Dear members of the Plan Commission,

Members of Friends of Starkweather Creek have been meeting with city Planning staff for the past year to discuss the Pumpkin Hollow Neighborhood Development Plan. Overall, we feel this plan is fairly good, but we still have some concerns. This letter first sets out some general comments and then lists some specific text changes we would like in the plan.

Comments from Friends of Starkweather, 11-07

Map 6: Land Use and Street Plan

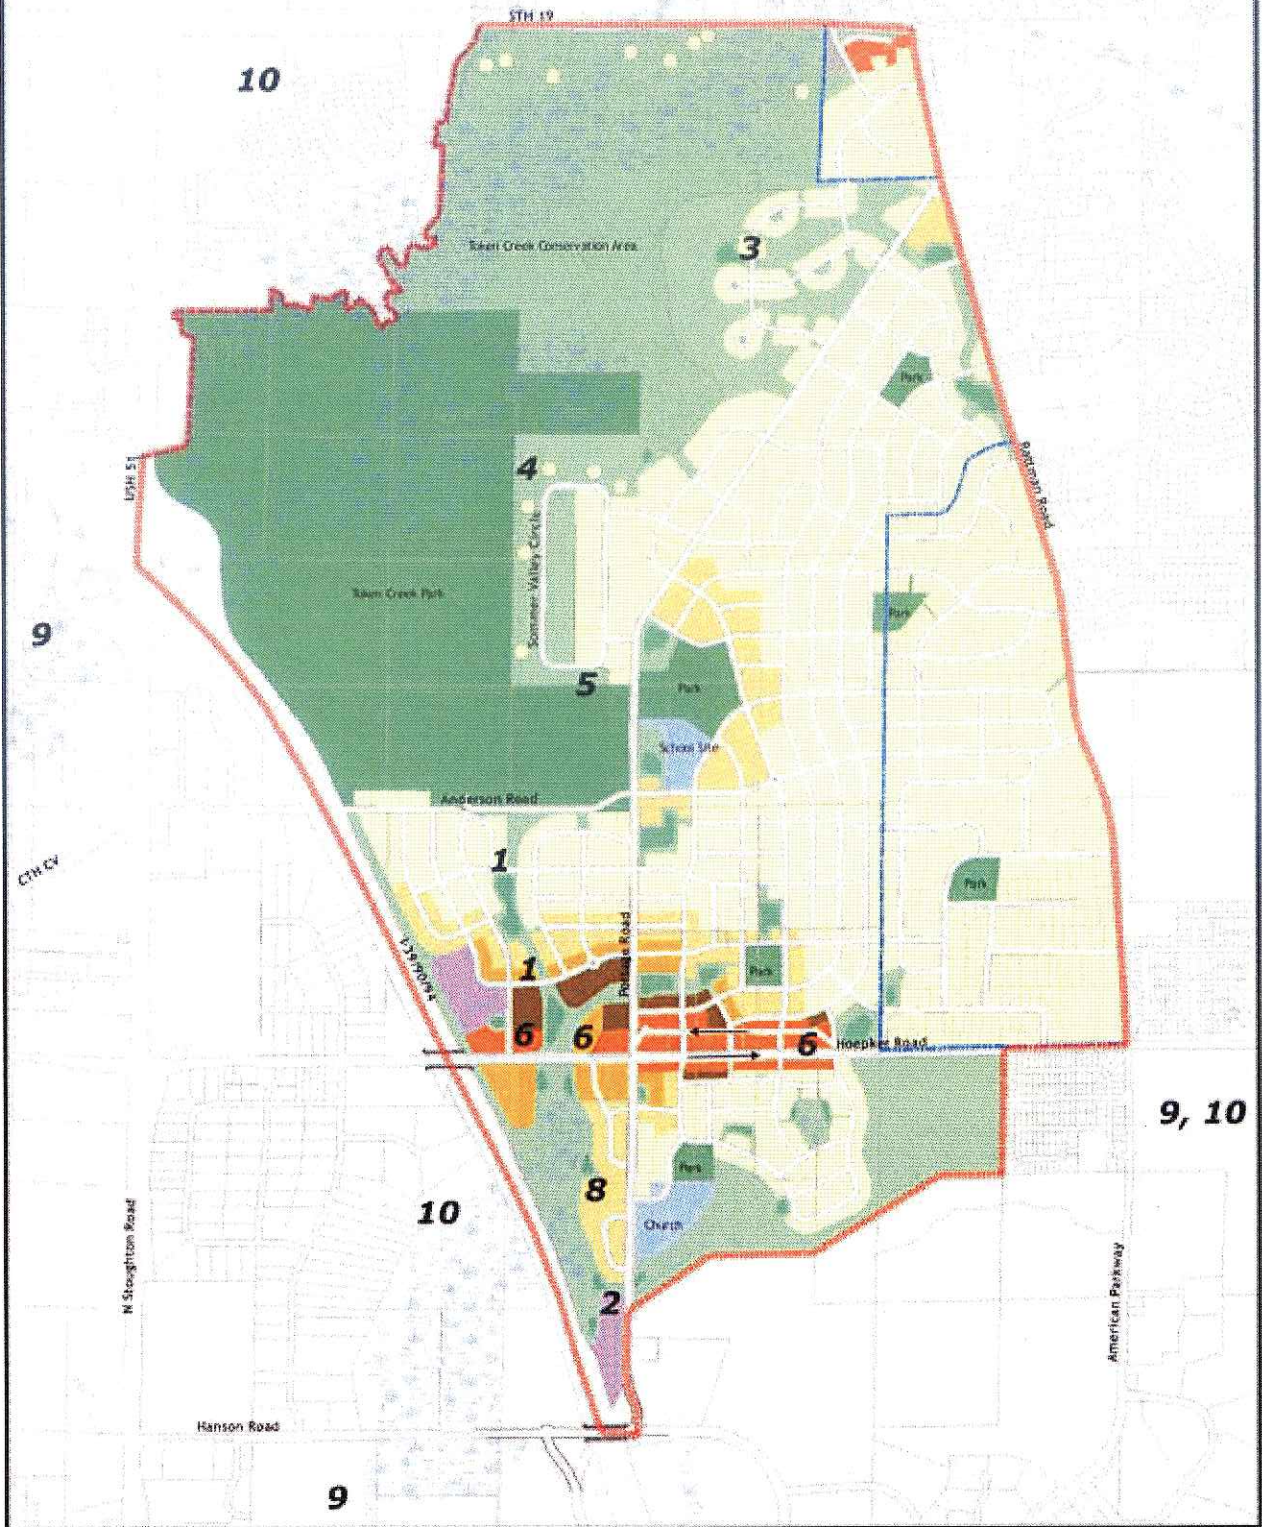
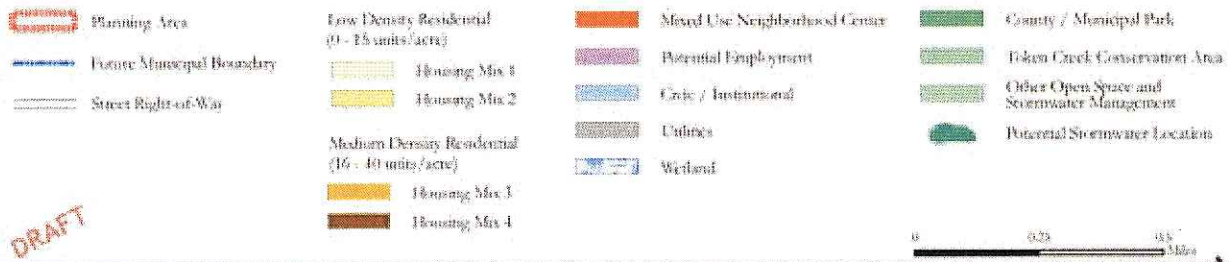
There are some "pinch points" where the Plan shows corridors as narrow as 70 feet. (See Map 6). We would like to see these bottlenecks removed to create continuous corridors as wide as possible.

We have included a copy of Map 6 marked with the locations of the specific comments below.

1. Please widen the creek buffer on the Starkweather branch between Hoepker and Anderson roads. The map shows the corridor as narrow as 80 feet total, minus a 10-15 foot wide bike path (or just 30 feet on either side of the creek). This corridor should be more wild and vegetated than just a drainage ditch or mowed swale.
2. There is a spot that a branch of Starkweather crosses Portage Rd south of Hoepker where the buffer is also too narrow. Please widen it as above to eliminate this bottleneck.
3. There is a spot where a coldwater tributary of Token Creek crosses a future subdivision road, west of Portage Rd, where the buffer is also too narrow. Please widen it as above to eliminate this bottleneck.

4. Sommer Valley Circle is surrounded by Token Creek Park and is very close to Token Creek wetlands. We disagree with the Plan recommendations (page 31) that would allow one additional subdivision of each parcel. Instead, the properties on the west and north side of the subdivision should be left as they are. Additional subdivision could be allowed in the rest of the parcels.

5. It may be desirable to provide pedestrian access to Token Creek Park from the southern end of Sommer Valley Circle, depending on the future site of the park entrance.

6. To reduce the impact of the neighborhood center on Starkweather Creek (see above), we suggest moving the high-density development east along Hoepker Road. Splitting Hoepker Road into two one-way pair streets here (as in the Pioneer neighborhood) would slow traffic and help create the feeling of an urban pedestrian friendly "downtown" center.

A different option would be to move the neighborhood center near the corner of Hoepker and American Family Parkway.

8. A street connection between two loop streets west of Portage and south of Hoepker would create better neighborhood connectivity instead of isolated developments.
